SR - 700 American Boulevard
SCHEMATIC DESIGN | LAND USE APPLICATION

SR - 700 American
700 W AMERICAN BLVD / BLOOMINGTON, MN

PRELIMINARY
NOT FOR CONSTRUCTION
SCHEMATIC DESIGN
CITY SUBMITTAL
10.11.2023
REVISIONS

1 GRADING, DRAINAGE, AND EROSION CONTROL PLAN

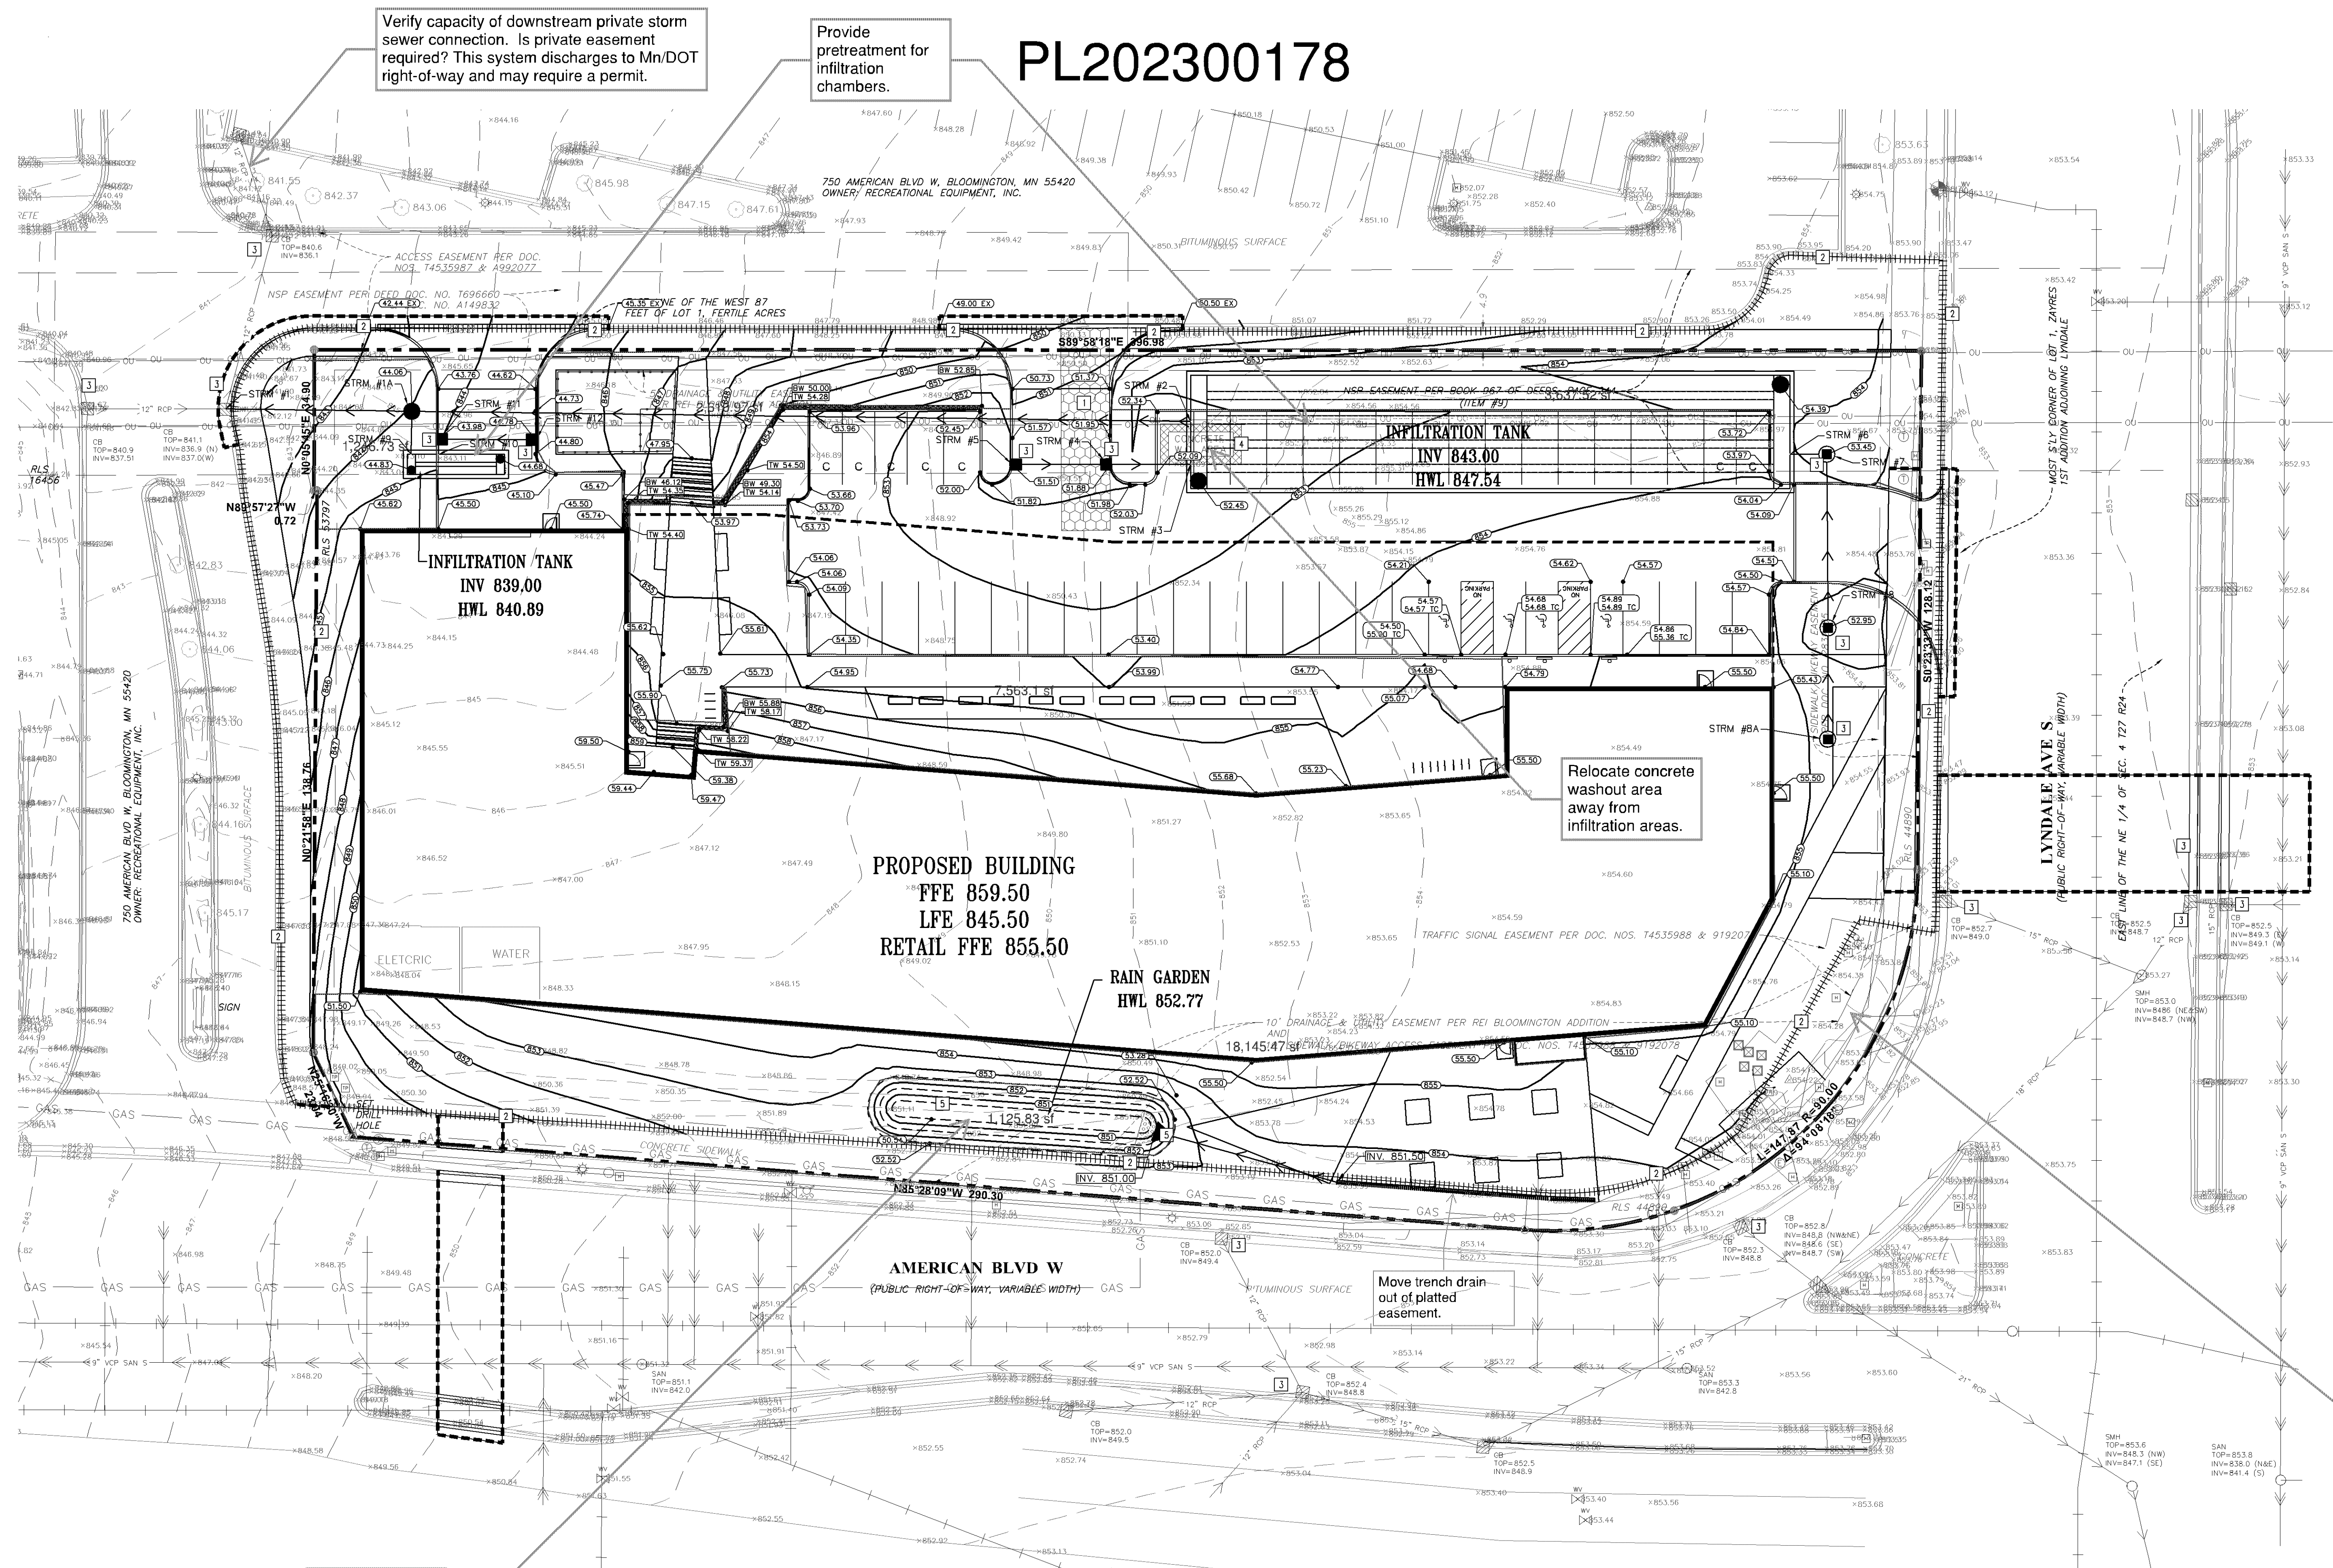
Verify capacity of downstream private storm sewer connection. Is private easement required? This system discharges to Mn/DOT right-of-way and may require a permit.

Provide pretreatment for infiltration chambers.

Relocate concrete washout area away from infiltration areas.

Provide piped overflow connection for rain garden.

Storm sewer needed in SE corner of site to collect snow melt before sheeting across sidewalk.

Show location of all inlet protection on SWPPP. Provide for overflow at low areas.

2 PROPOSED CONDITIONS
C600.0
1" = 30'

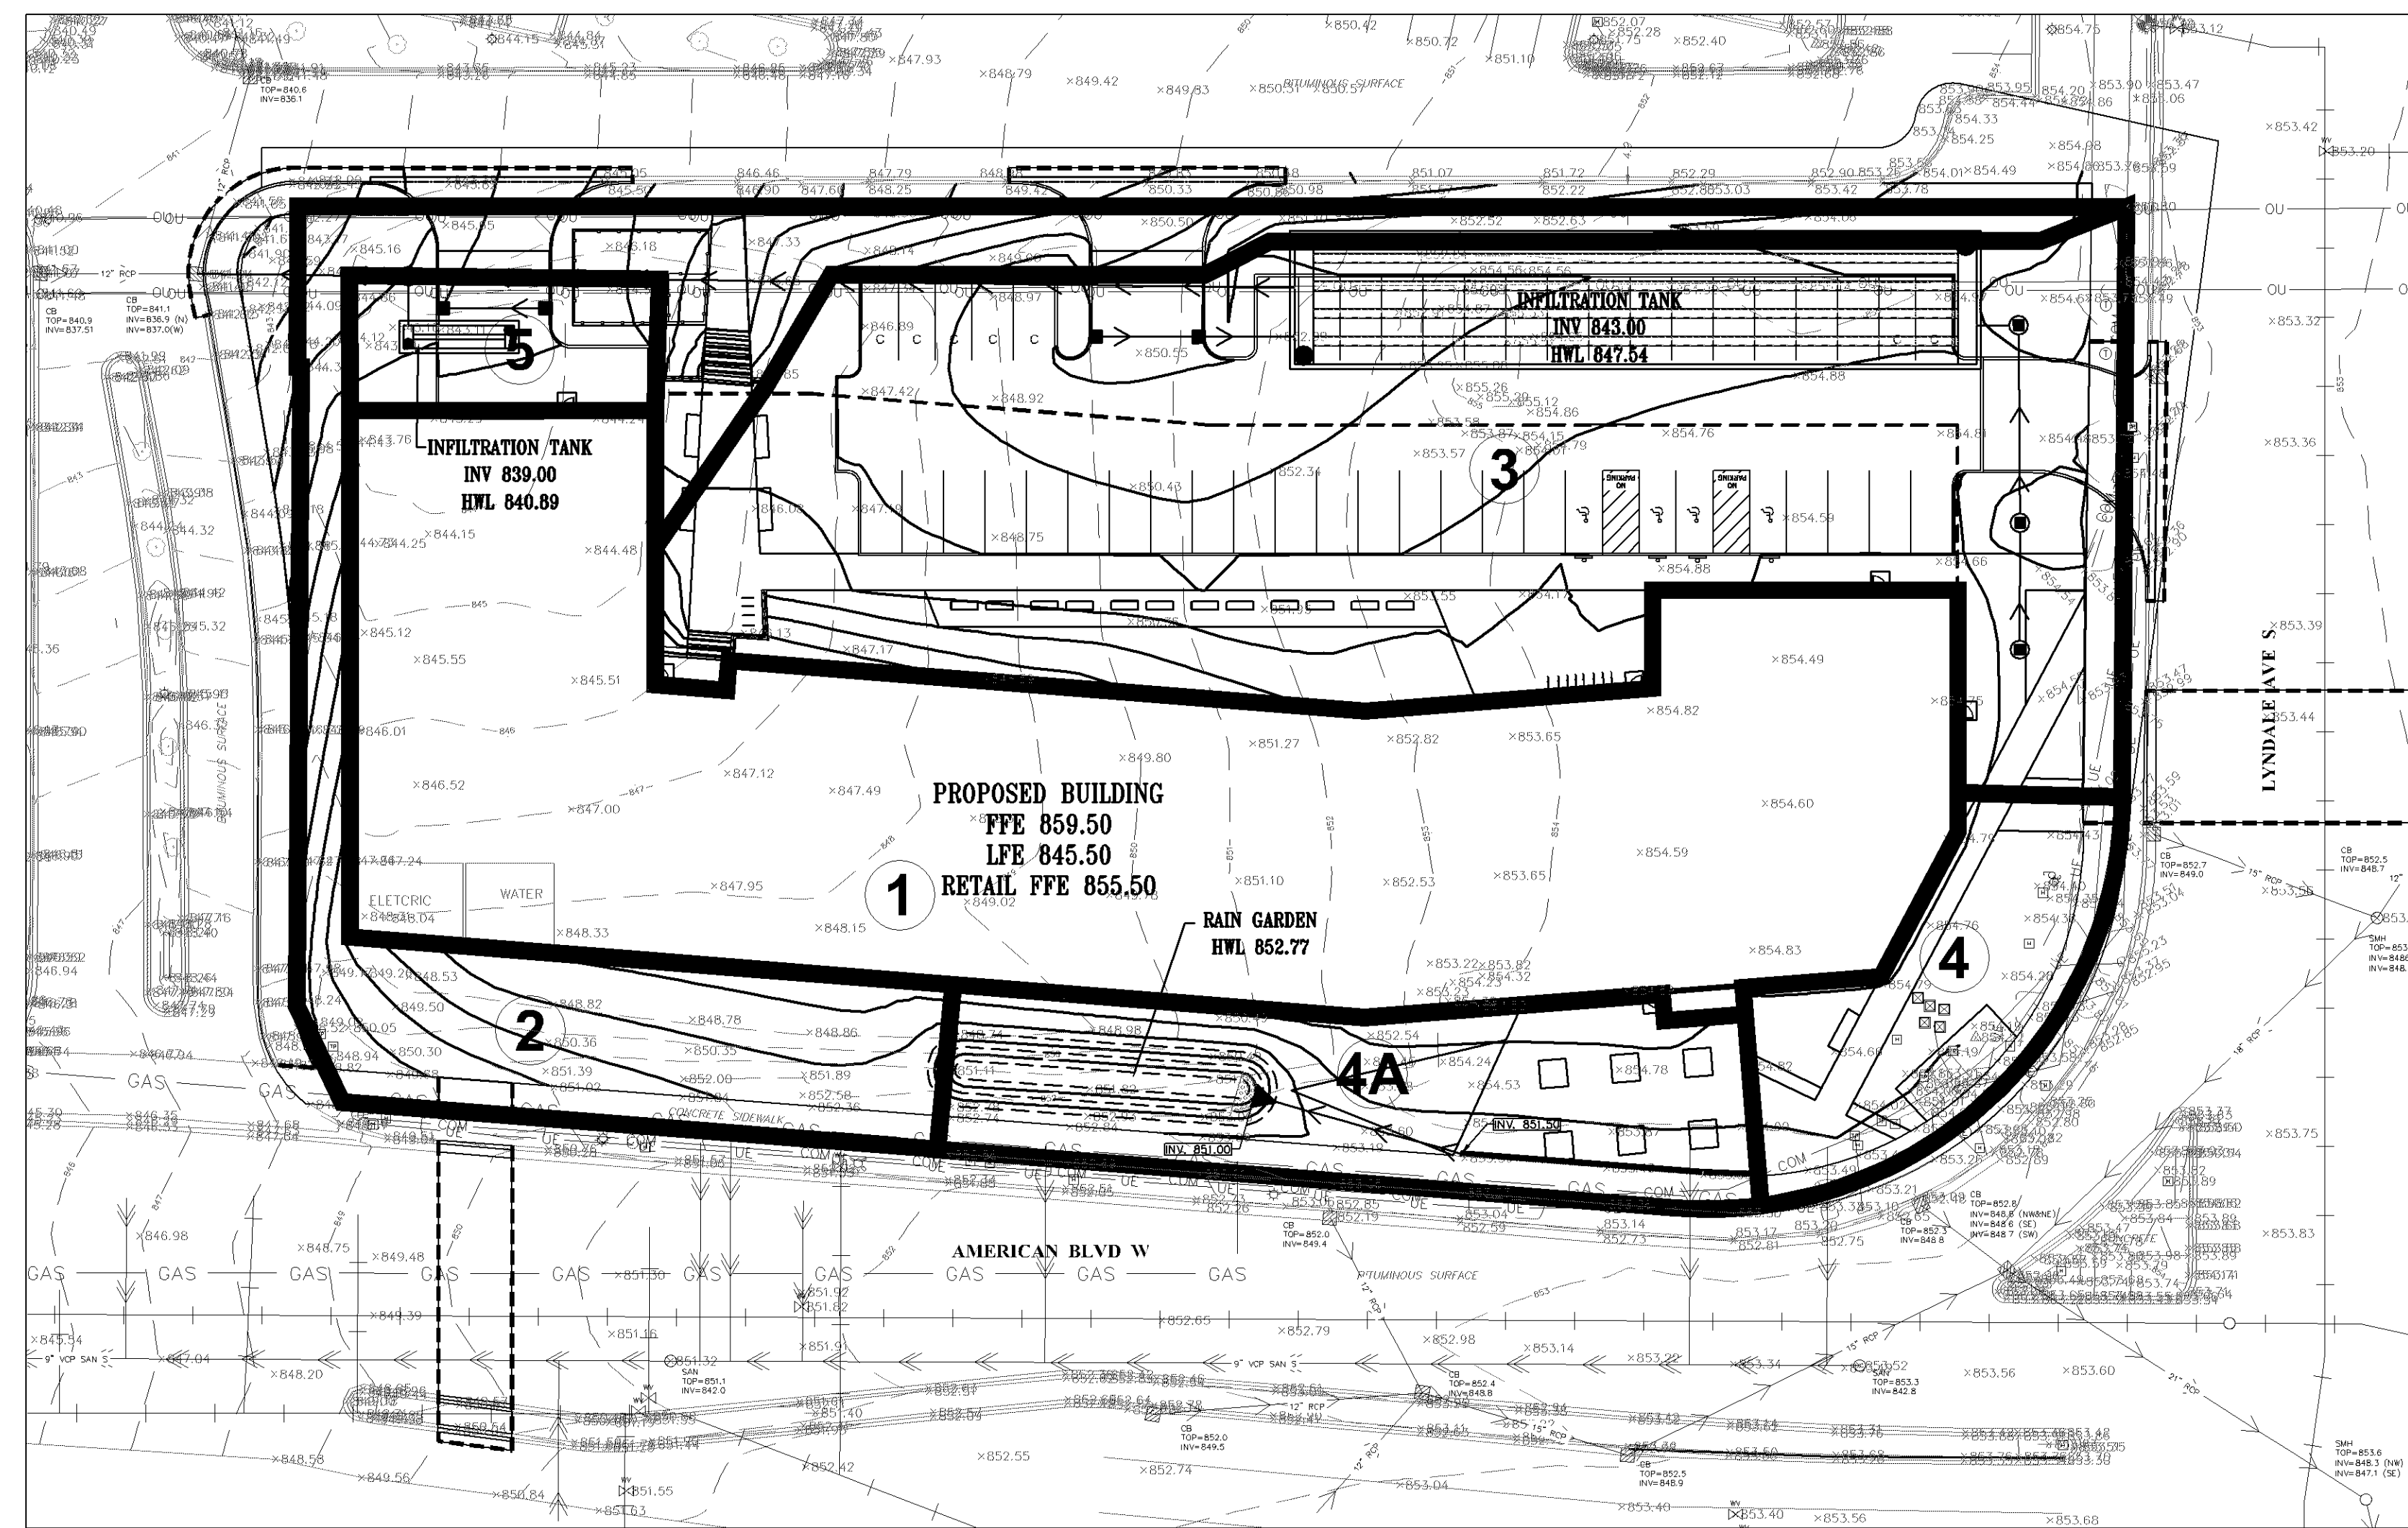
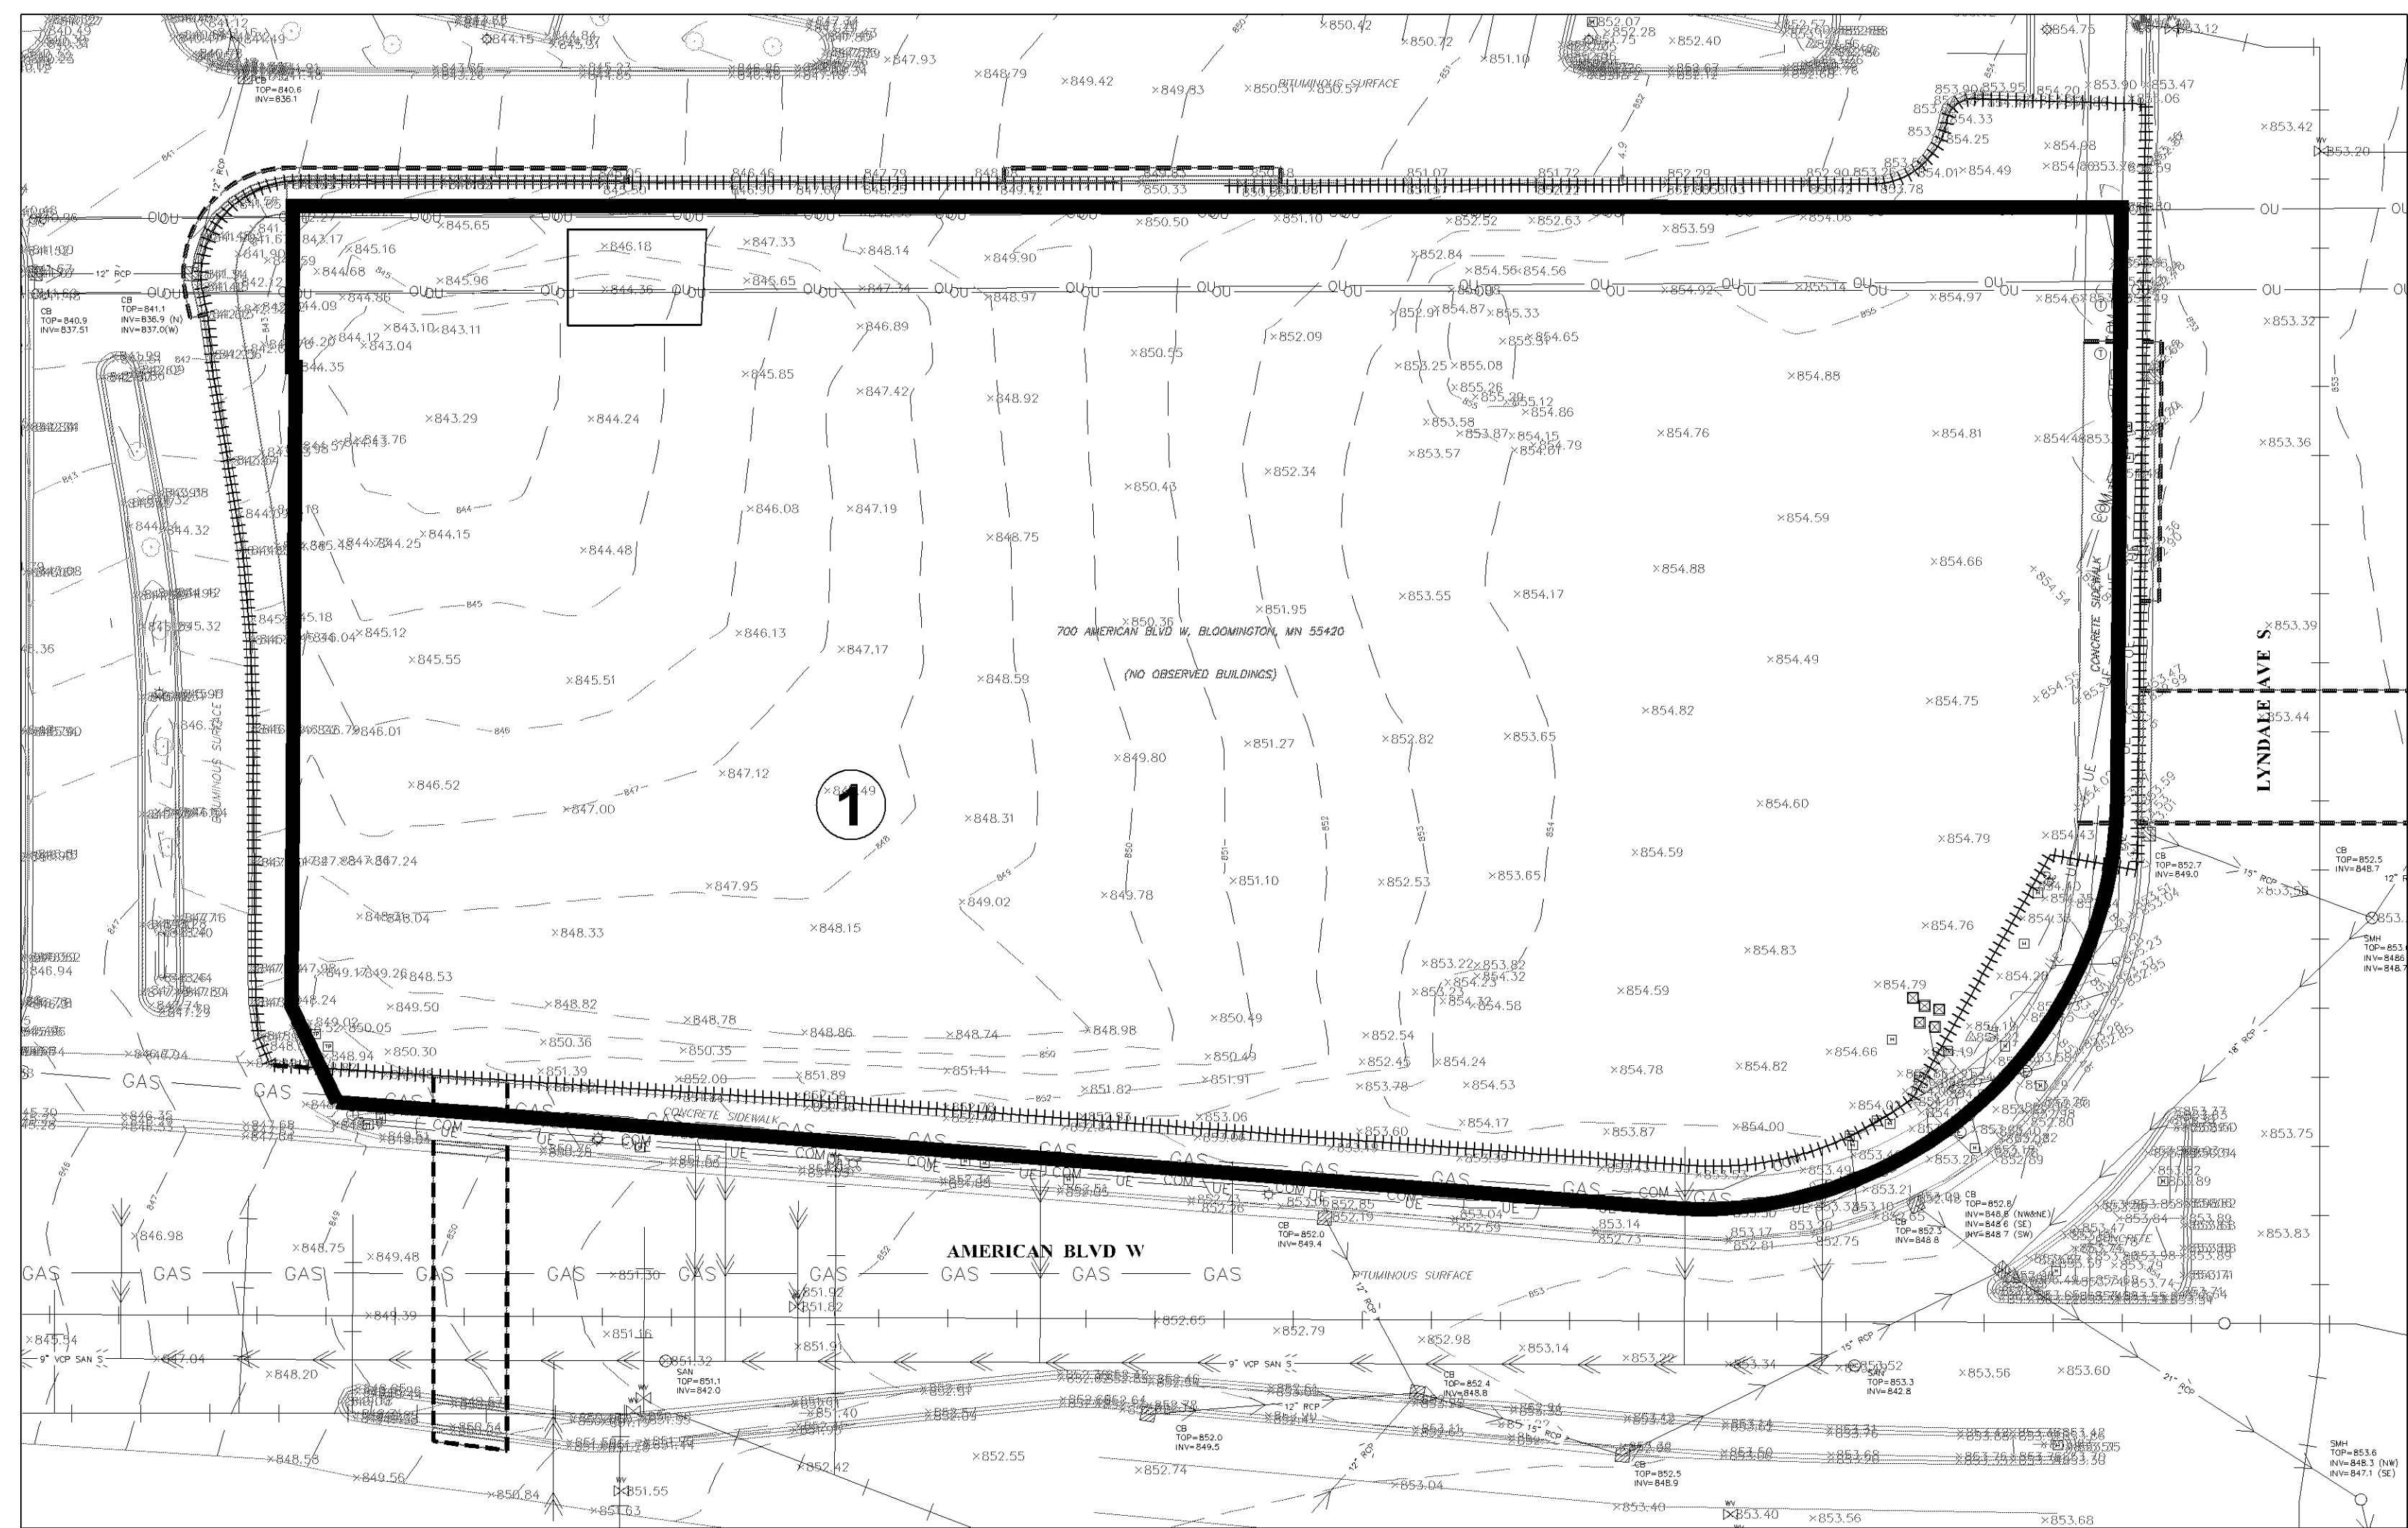
Verify site location on SWPPP.
